PHILADELPHIA ELECTRIC COMPANY

SUBJECT: Response to the NRC Request For Additional
Information regarding the Plan for Restart of
Peach Bottom Atomic Power Station, Revision 1.

**PHILADELPHIA ELECTRIC COMPANY
RESPONSE TO REQUEST FOR
ADDITIONAL INFORMATION ON PLAN
FOR RESTART OF PEACH BOTTOM ATOMIC
POWER STATION, REVISION 1**

Figure 8. Independent Assessment Function Information Flow and Feedback Loop (After)

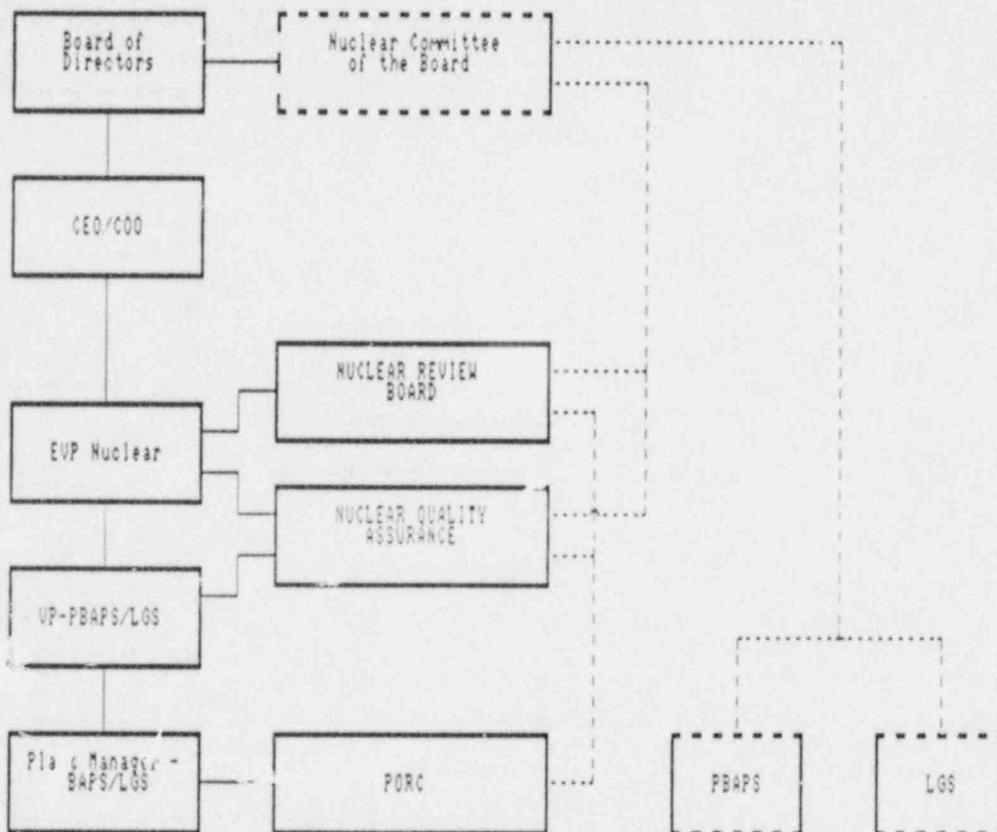
NRB review of organizational and personnel performance issues has been deleted from the plan. Explain who will address these issues.

PE's line management has the primary responsibility to address all organizational and personnel performance issues. The Nuclear Committee of the Board (NCB), in accordance with its oversight mission, has the responsibility to review on a continuing basis and report to the full Board on the management of nuclear operations, including but not limited to organizational issues and the performance and overall effectiveness of the senior nuclear management team. The role of the Nuclear Review Board (NRB) is further elaborated upon in the responses to questions I-30 and I-31.

The charge of the NCB, its specific duties, membership, resources and organizational relationships are discussed in Section 4.4 through 4.7 and in the attached revised Figure 8 of Section 1 of the Plan for Restart of Peach Bottom.

Reporting Relationships Manager, Nuclear Engineering/Construction Managers-LGS-2

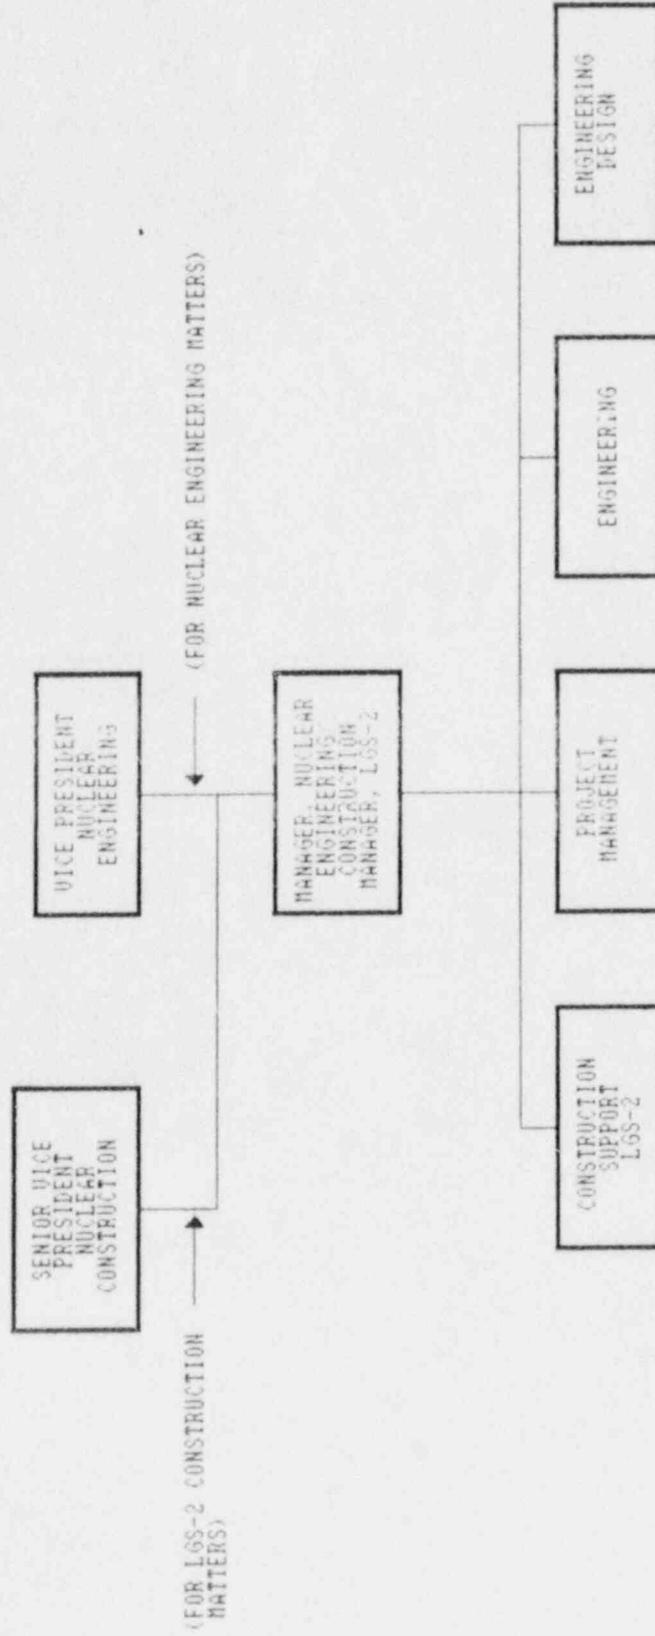
Correct the inconsistency between figure 4 which shows LGS-2 construction management reporting to a Manager under the Vice President Nuclear Engineering and figure 1 which shows LGS-2 construction management report to the Senior Vice President Nuclear.

What might appear to be an inconsistency between Section I, Figure 1 on page 9, and Figure 4 on page 24 of Section I of the Restart Plan is explained on Page 26. The Manager, Nuclear Engineering, has two major roles. In one role he reports directly to the Vice President-Nuclear Engineering in a one-over-one relationship. In the other role he serves as the Construction Manager-LGS-2 and reports directly to the Senior Vice President-Nuclear Construction as indicated in Figure 1. In the role of Construction Manager-LGS-2, the Manager, Nuclear Engineering, has as his direct report, the Construction Superintendent-LGS-2, as indicated in Figure 4. A figure showing the dual reporting relationship of the Manager, Nuclear Engineering/Construction Manager-LGS-2 is attached.

Figure 8. Independent Assessment Function Information Flow and Feedback Loop (After)

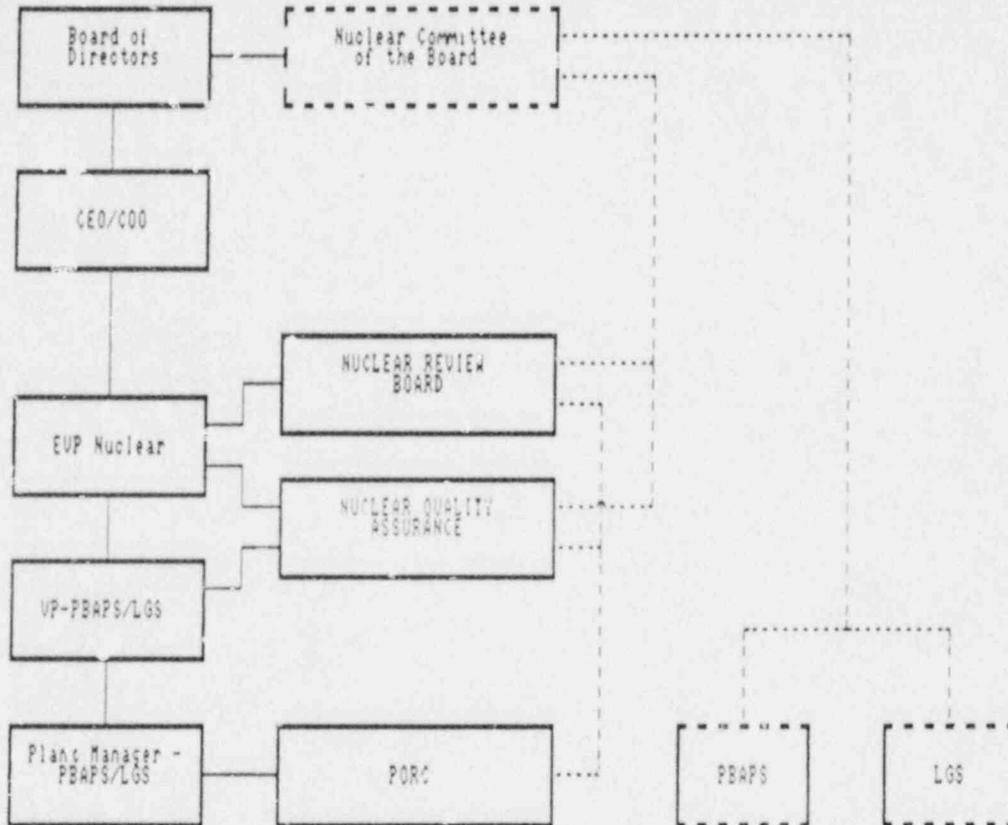
Activity Numbers CA4-3.4.1-3. Explain why these items regarding independent assessment of review and feedback processes used by independent assessment groups were deleted. In addition, describe what aspects of the restart plan will be assessed in the scheduled Self Assessment. Who will perform the Self-Assessment? Will written audit procedures or plans be used in this Self Assessment? How will these procedures or plans be prepared, reviewed and approved? How will these documents be used in the assessment. What other inputs will be used in reaching conclusions or recommendations in the Self Assessment?

As shown in the attached revision to Figure 8 of Section I of the Plan for Restart of Peach Bottom, the NRB and NQA report directly to the Executive Vice President-

Nuclear. Both the NRB and NQA provide information to the NCB on a continuing basis, to assist the NCB in fulfilling its oversight mission regarding the effectiveness of management of nuclear operations, including but not limited to nuclear organizational issues and senior nuclear management effectiveness. Programmatic assessments by NQA provide information regarding the effectiveness of Nuclear Operations Management directly to Executive Vice President - Nuclear, NCB, and NRB.
